UNITED STATES
DEPARTMENT OF THE INTERIOR
BUREAU OF LAND MANAGEMENT

FORM APPROVED
OMB NO. 1004-0137
Expires: January 31, 2018**SUNDRY NOTICES AND REPORTS ON WELLS**
Do not use this form for proposals to drill or to re-enter an abandoned well. Use form 3160-3 (APD) for such proposals.
DISTRICT OFFICE ARTESIA O.C.D.**SUBMIT IN TRIPLICATE - Other instructions on page 2**

Dexter Federal #9
30-015-30328

Permanent Abandonment of Federal Wells
Conditions of Approval (LPC Habitat)

Dexter Federal #9 Wellbore diagram

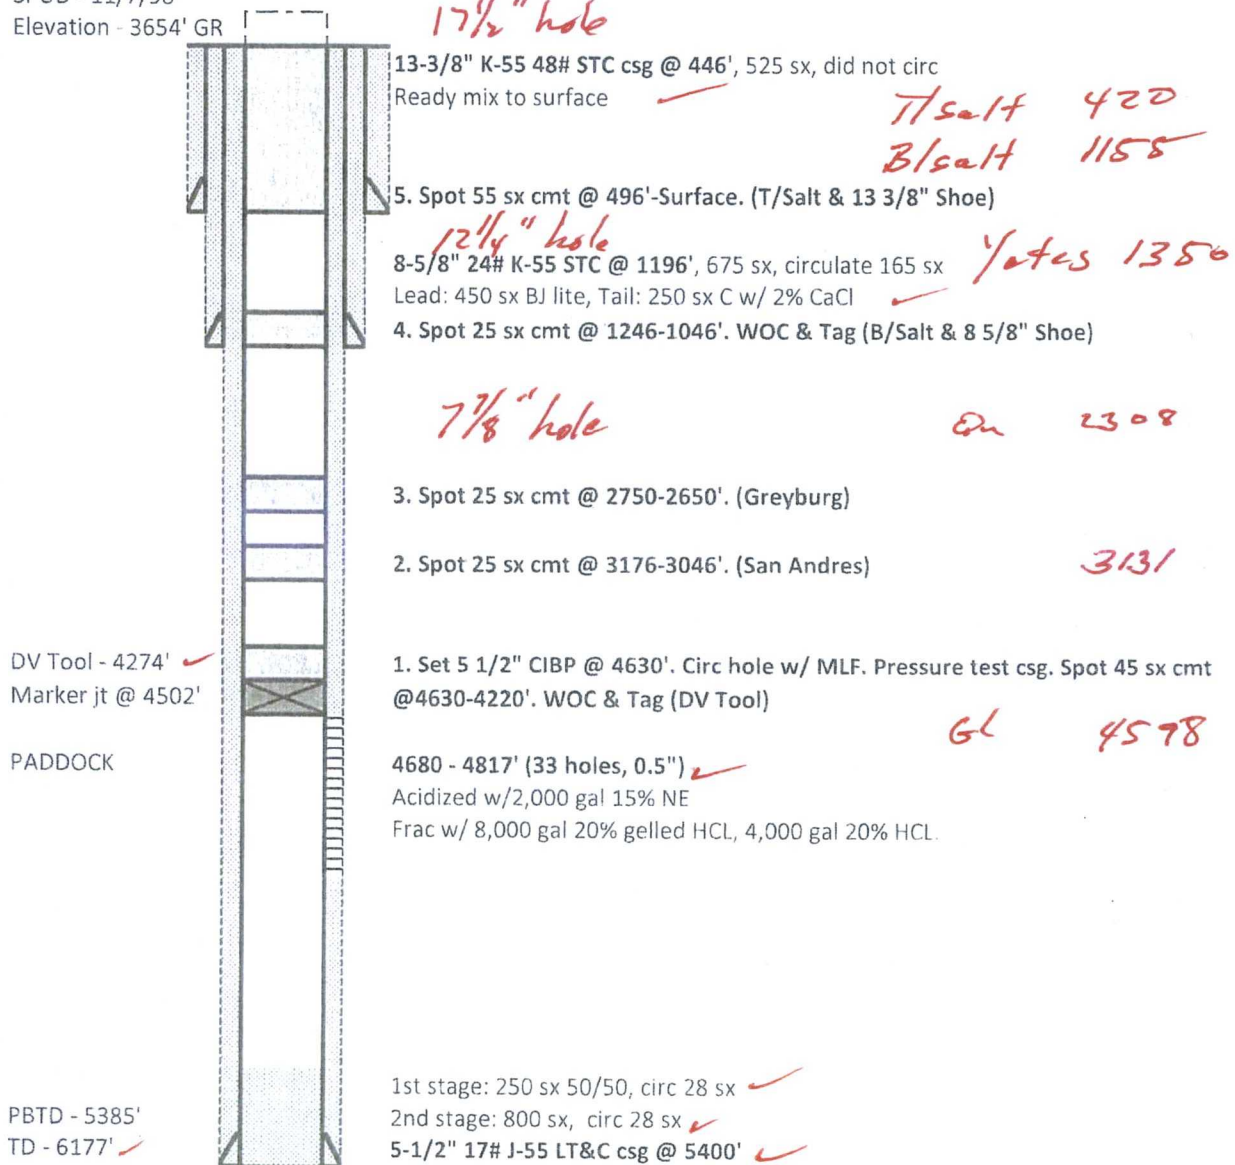
**SEE ATTACHED FOR
CONDITIONS OF APPROVAL***GC 5-17-18
Accepted for record - NMOCD**Below ground level dry hole marker required*

**** BLM REVISED ** BLM REVISED ** BLM REVISED ** BLM REVISED ** BLM REVISED ****
